REQUEST FOR INFORMATION DATE: May 27, 2016 NO.: RFI-115

Project Name: 15051-Webster University Interdisciplinary Science Building Project No.: 15051

Subject: Transfer Duct Detail

RETURN AIR TRANSFER DUCT THRU SOUND-RATED PARTITION

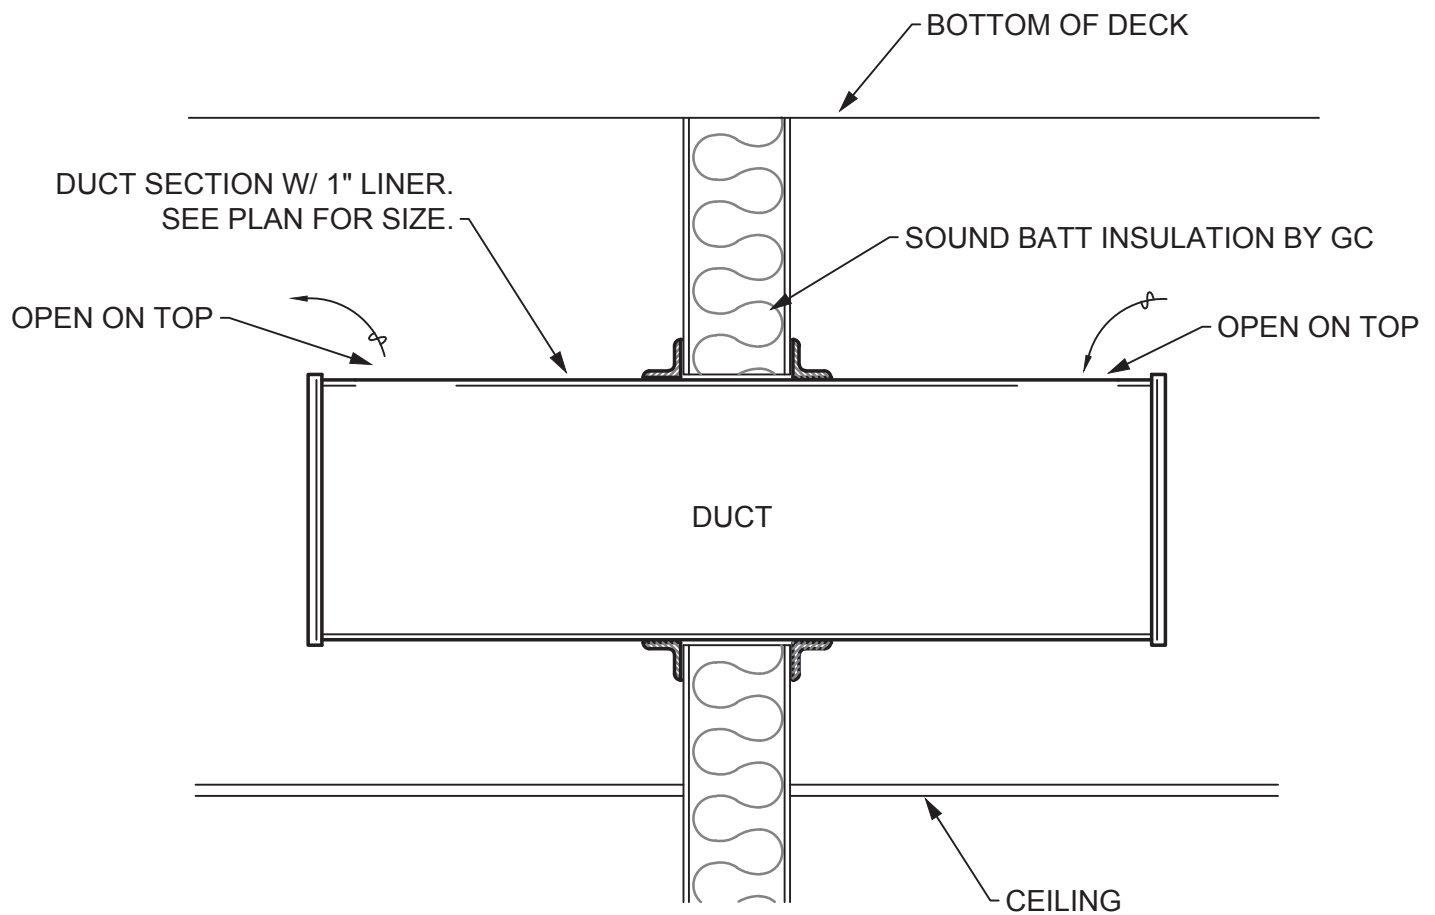
Mechanical contractor uses the attached transfer duct detail as our sheet metal shop standard. We would match the spec'd liner and the opening sizes marked on the drawings.

Is it acceptable to use the attached transfer duct detail in lieu of the transfer duct detail on drawing M0502

Proposed transfer detail is acceptable.
